# UNITED STATES PATENT AND TRADEMARK OFFICE

APPLICATION NO.	FILING DATE	FIRST NAMED INVENTOR	ATTORNEY DOCKET NO.	CONFIRMATION NO.
10/554,172	10/24/2006	Jacobo Mugica Miguel	15053.0016USWO	7642
23552	7590	12/27/2007	EXAMINER	
MERCHANT & GOULD PC			NGUYEN, TAM M	
P.O. BOX 2903			ART UNIT	PAPER NUMBER
MINNEAPOLIS, MN 55402-0903			3764	
			MAIL DATE	DELIVERY MODE
			12/27/2007	PAPER

<b>Office Action Summary</b>	Application No. 10/554,172	Applicant(s) MUGICA MIGUEL ET AL. <span style="float: right;">CT</span>	
	Examiner Tam Nguyen	Art Unit 3764

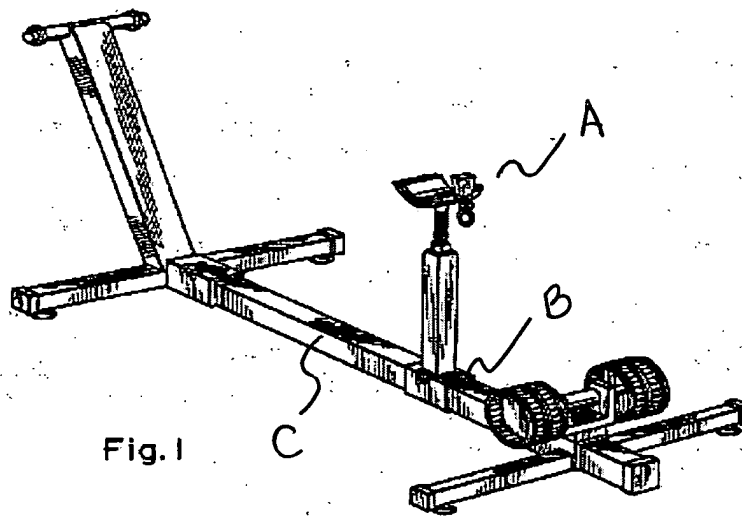
6. As to claims 1, 3 and 8, Defaux discloses a training bench having a framework (30) with two or more longitudinal bars, rotational rollers (31,31A) located between the bars, and a central support that includes a platform (35) assembled on the framework through transverse bars (35) on which it can move in a free or regulated manner, serves

as a holding base for a vertical column and provides a support means for the frame of the bicycle on its free end wherein the anchoring system acts as an absorption member to control the movement of a bicycle coupled to the platform and framework and the central support is connected to the pedal set casing of the bicycle (see Figs. 1 & 9).
